Response to Further Advice – P004169 (MCU26/0400)

Q50 STORMWATER CATCHMENT PLAN

DRAWING SIZE	SCALE	DRAWING NO.	REV
A1	1:2000	STG004/85	D

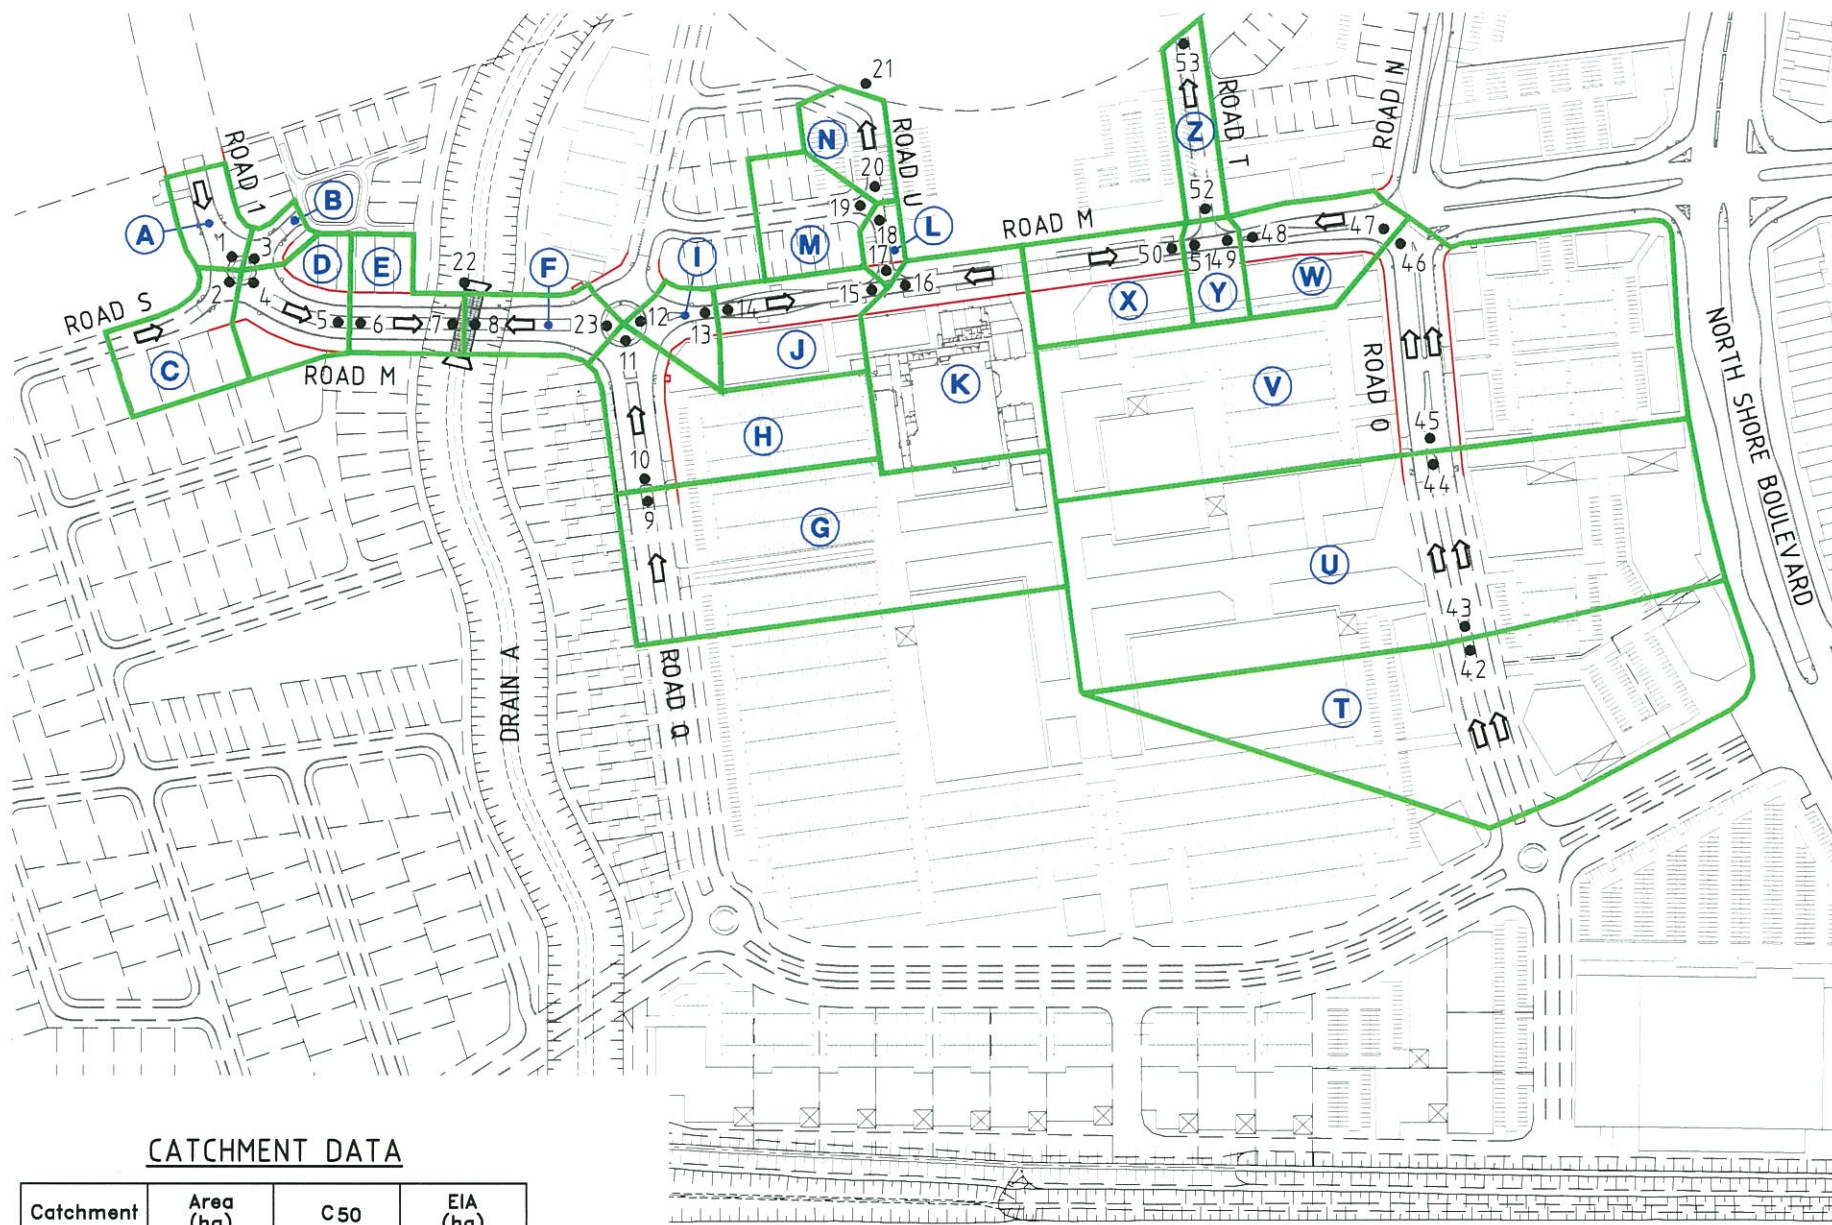
In response to Council's comments regarding the predicted 1% AEP afflux (100–200 mm) within Market Street east of the development site, we note the following.

The afflux identified within the Flood Impact Assessment was therefore expected. Our review indicates that Council's flood model does not fully account for the existing approved drainage infrastructure and overland flow arrangements within Market Street. As a result, the model does not accurately represent the hydraulic behaviour intended under the approved stormwater design.

Market Street was originally designed to accommodate runoff from the subject development area. As shown on the approved stormwater catchment plan (Drawing STG004/85), Market Street forms part of the intended drainage network for Catchments T, U and V. These catchments are broadly consistent with the contributing catchment identified in Figure 2.5 of the Flood Impact Assessment.

Accordingly, the conveyance of runoff through Market Street is not a new consequence of the proposed development, but rather an outcome that was anticipated and incorporated into the approved drainage design.

Accordingly, the identified afflux is considered to reflect limitations in the representation of the approved drainage infrastructure within the underlying flood model rather than an adverse flooding impact caused by the development.

On this basis, we consider that additional mitigation measures are not warranted, as the approved drainage network already provides for the conveyance of runoff from the contributing catchments and the development does not materially alter the intended flood conveyance function of Market Street.
